Docket Item # 3  
BAR CASE# 2009-0035

BAR Meeting  
April 7, 2010

**ISSUE:** Alterations and Waiver of Screening

**LOCATION:** 202 Duke Street

Figure 5: View of side yard at entrance – Portion not within open space easement

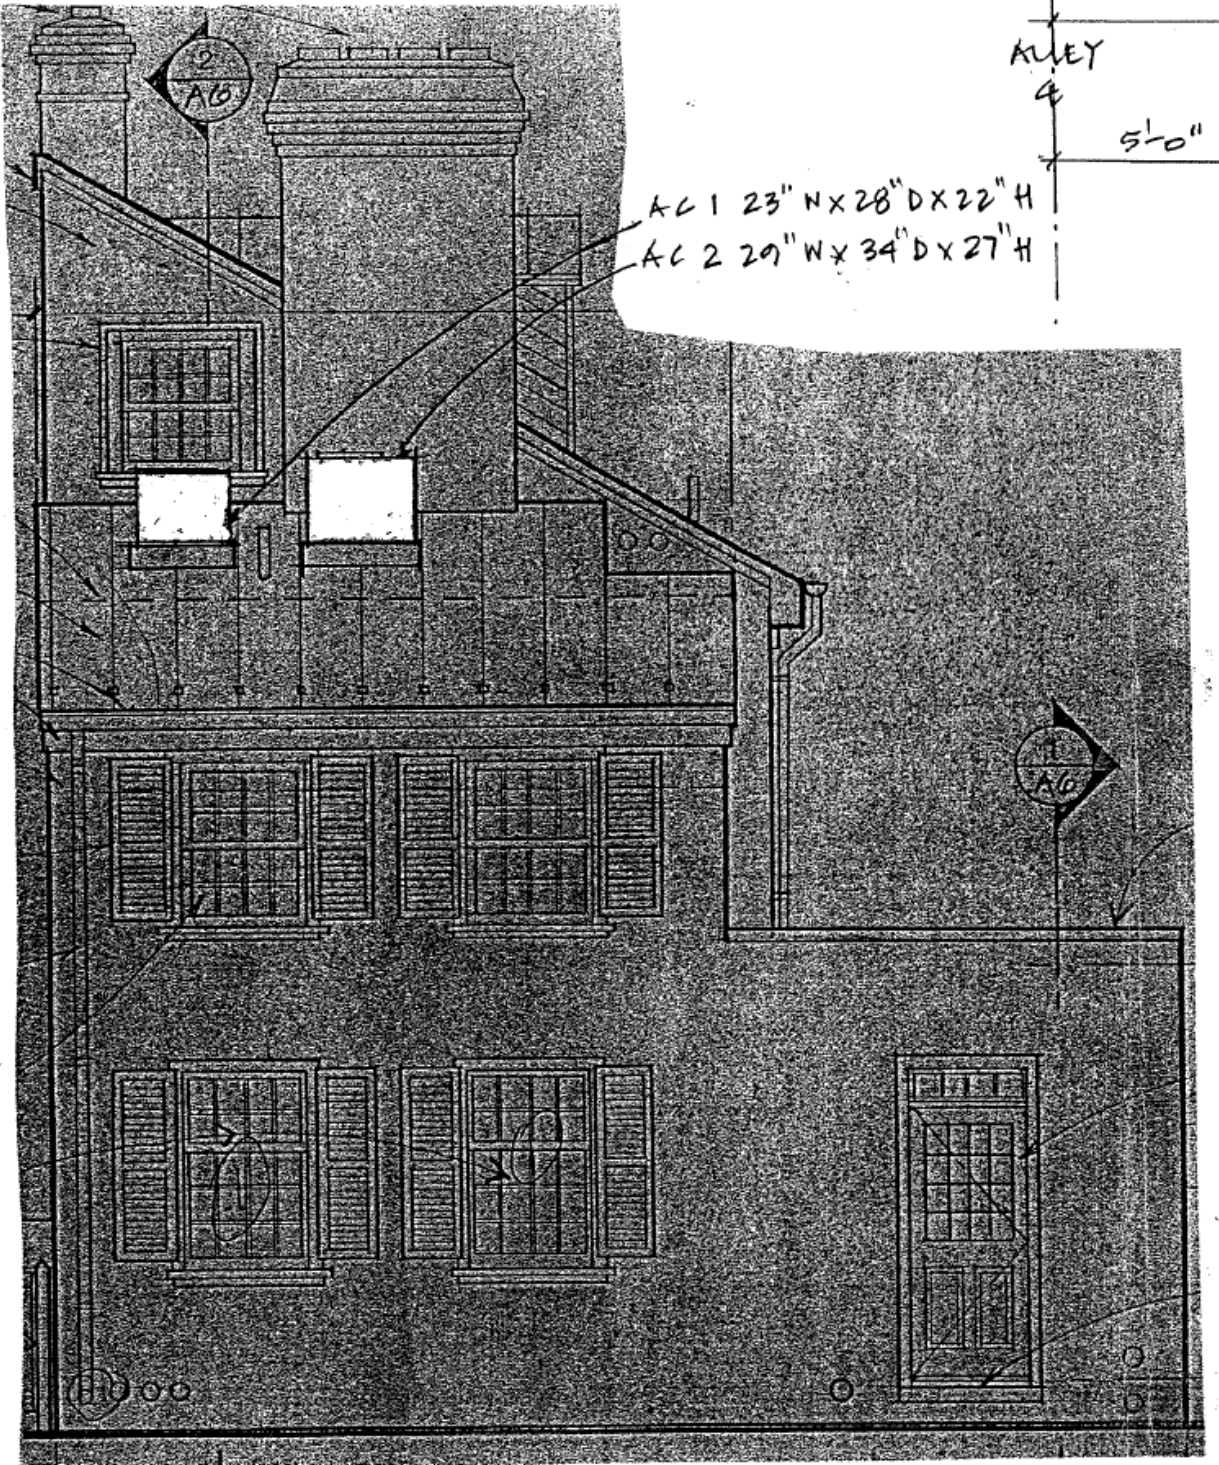
Where possible, Staff's preference is to locate HVAC units on the ground and out of public view. Although noise is not within the BAR's purview, staff also generally encourages applicants to locate units where they will not be a nuisance to neighbors. However, in this instance, there is no space available on the ground. The Alexandria Historical Restoration & Preservation Commission holds an open space easement on the entire yard area north of the building (figure #9). The Commission has confirmed at their recent meeting that HVAC condensers are not permitted within the easement (correspondence attached). The only remaining ground level space is a narrow side yard which leads to the front door and basement stairs. As is evident in the attached photograph taken by staff (figure #5), there is no practical location within this side yard for two HVAC condensers or screening.

2 SOUTH ELEVATION  
1/4" = 1'-0"

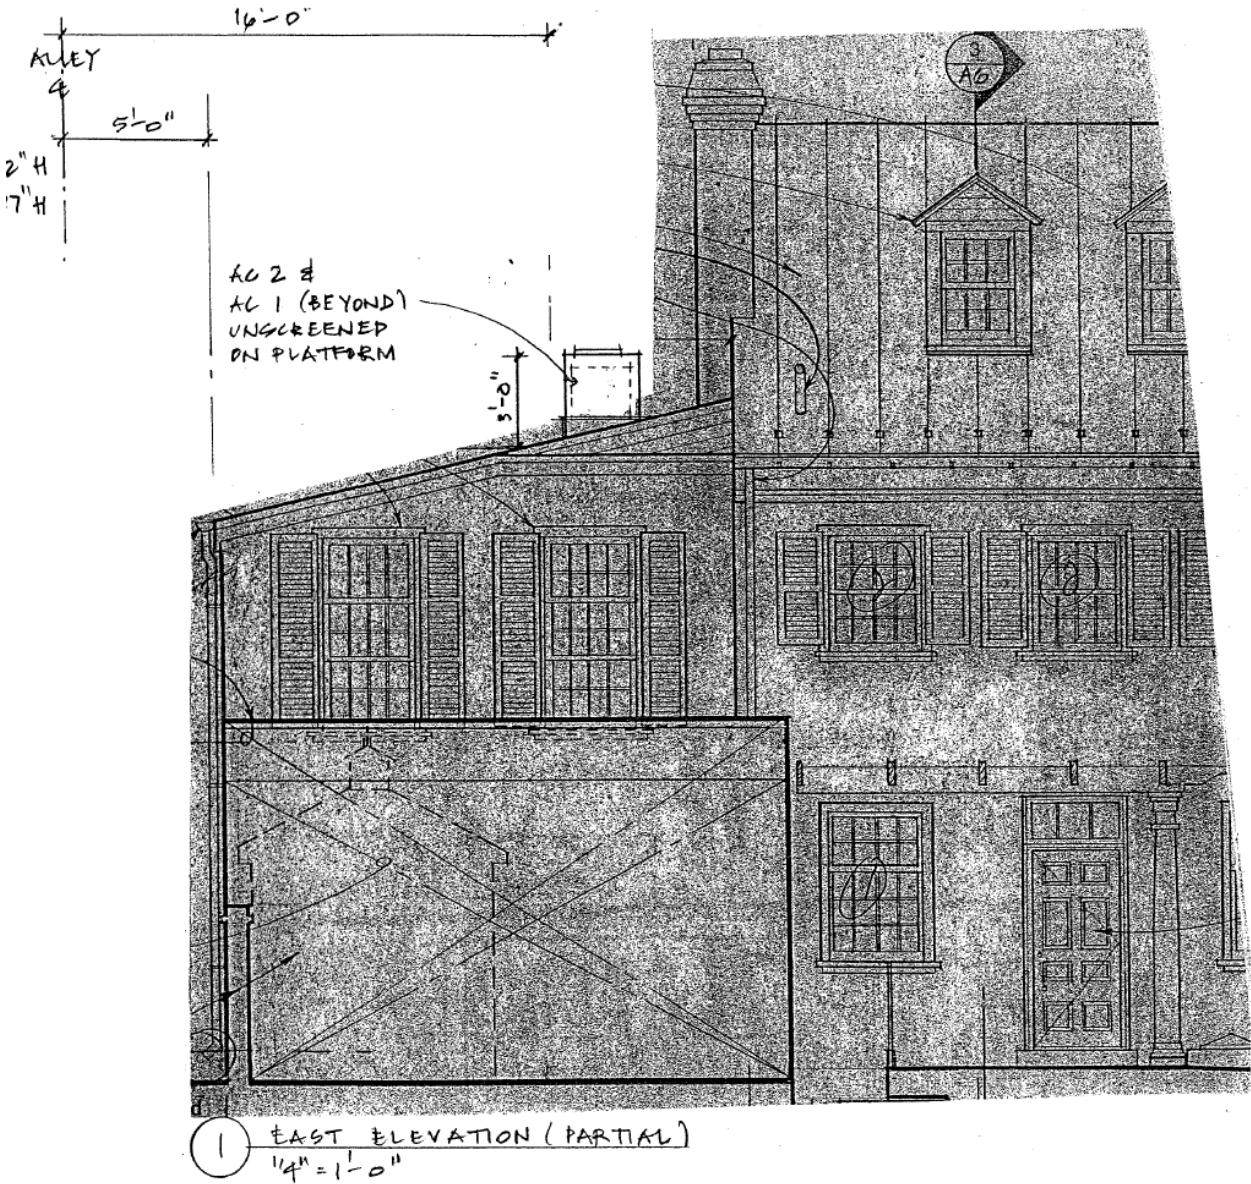
As in the previous report, Staff continues to believe that the proposed condensing units are minimally visible from the public way, even without taking into account the several trees that effectively screen the rear of this property, and would draw less attention to themselves if they were simply painted oxide red to match the adjacent roof/wall surface. Additionally, there are existing rooftop condensing units located on houses to the rear, immediately adjacent and on each side of the subject property which are minimally visible from the public way.

Figure 7: Plan of Front Entry with proposed AC condenser placement  
(Sketch drafted by BAR Staff per the request of the BAR)

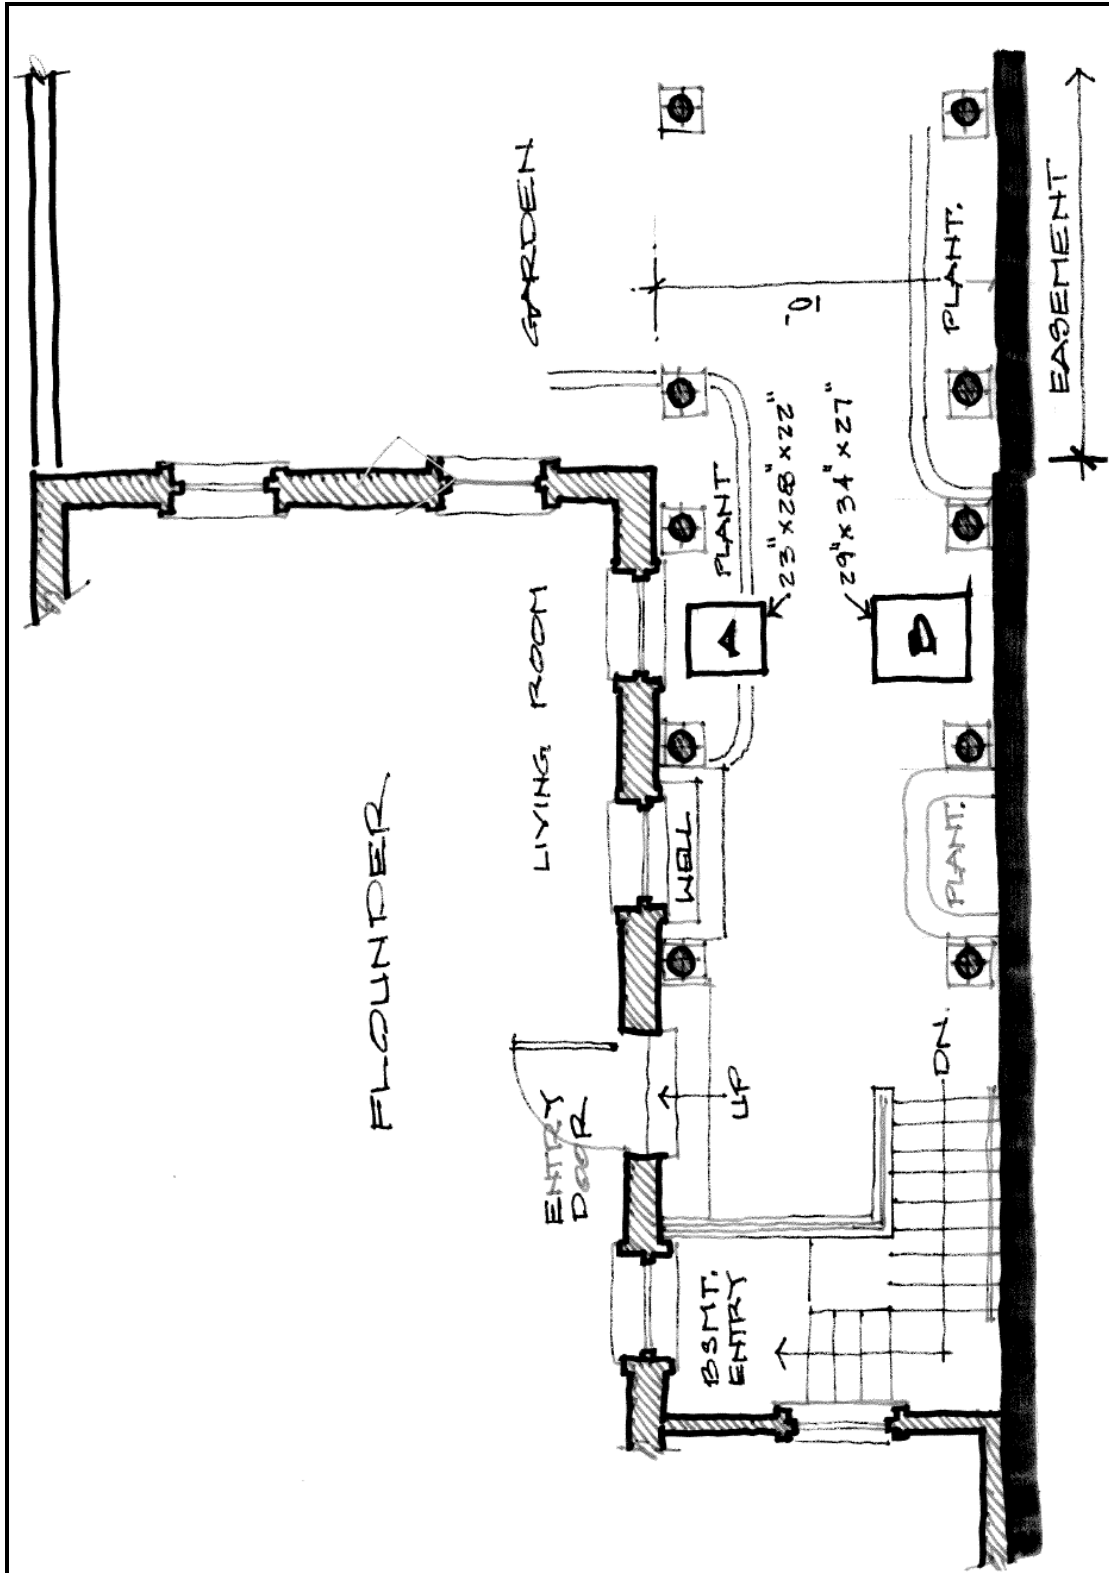
Secondly, upon evaluation of the front entry corridor, Staff has confirmed this is not an appropriate location for the proposed units (see attached drawing). Positioning the condensers in the corridor would impact the current walkway width which is already minimal and this location is discouraged in the letter from the Preservation Commission because of the adverse effect it would have on the view from the open space easement.

Figure 8: Elevation Sketch with proposed balustrade “Screen”

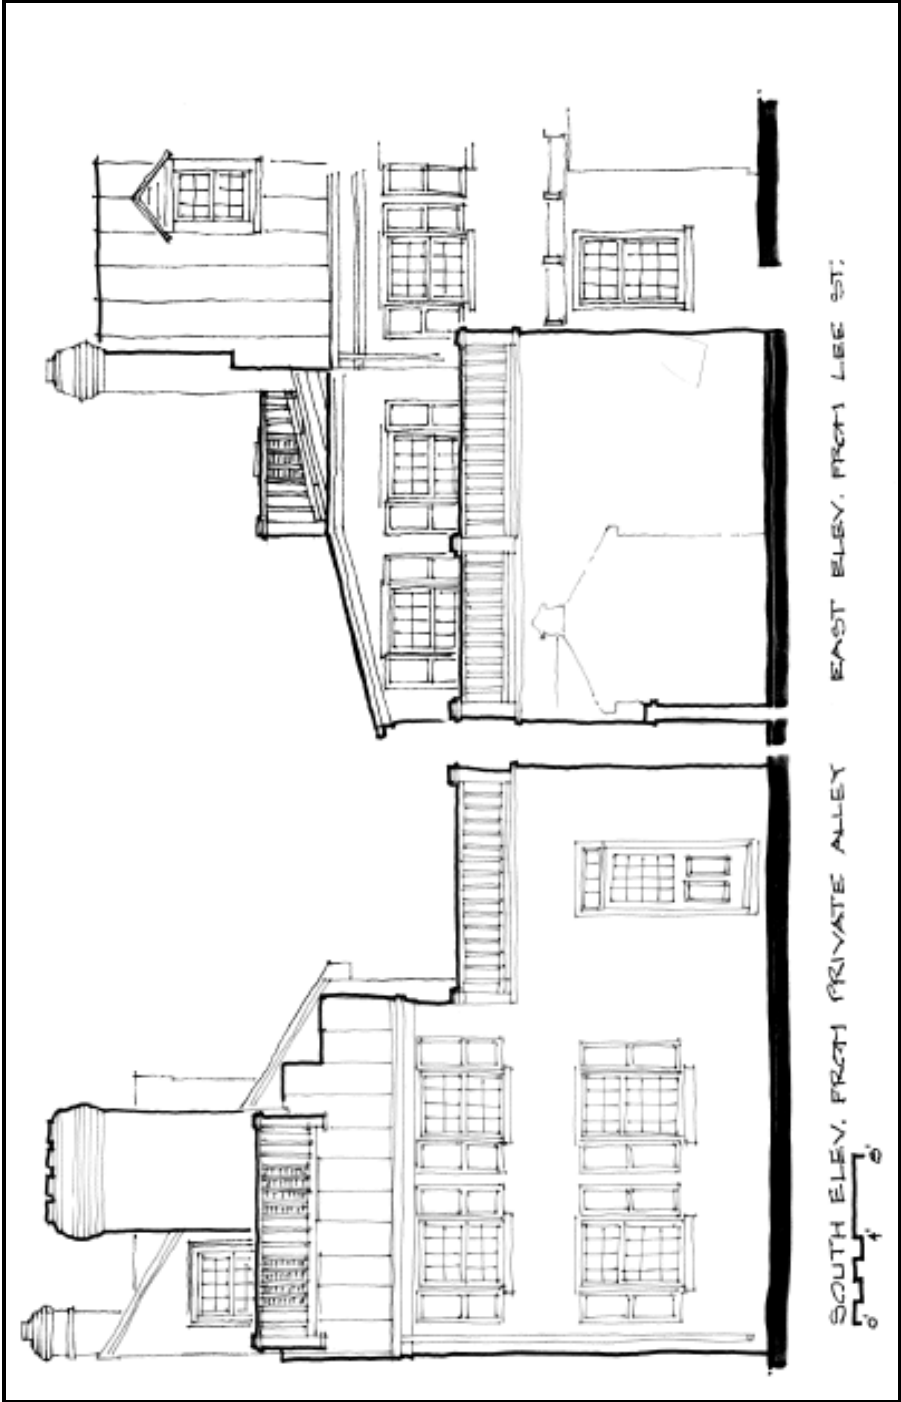
Finally, attached is the Board requested sketch for a rooftop screen for the condensers in their current proposed location.

However, Staff is well aware of the substantial neighborhood concern for the visibility of these units from Lee Street and is recommending installation of a screen designed to match the existing railing of the second floor terrace on this dwelling. The suggested wood railing is translucent enough to obscure the units while the balusters are open enough to allow adequate airflow even if the railing is placed relatively close to the condenser. There is a flat spot on the slope of the roof which creates the logical architectural illusion of a third floor terrace. The applicant has no objection to installation of the railing and has agreed to work with staff on the details of the installation, if the requested waiver of rooftop screening requirement is denied by the Board.

1. That the condenser units be painted an oxide red color to match the adjacent standing seam roof.
2. If the mechanical screening is not waived by the Board, a mechanical screen should be constructed to match the design of the existing railing at the second floor terrace.
3. That the applicant verify on the plat submitted for building permit that the rooftop HVAC condenser units comply with the rear yard setback of 16 feet to the center line of the alley, in compliance with the Zoning Ordinance.
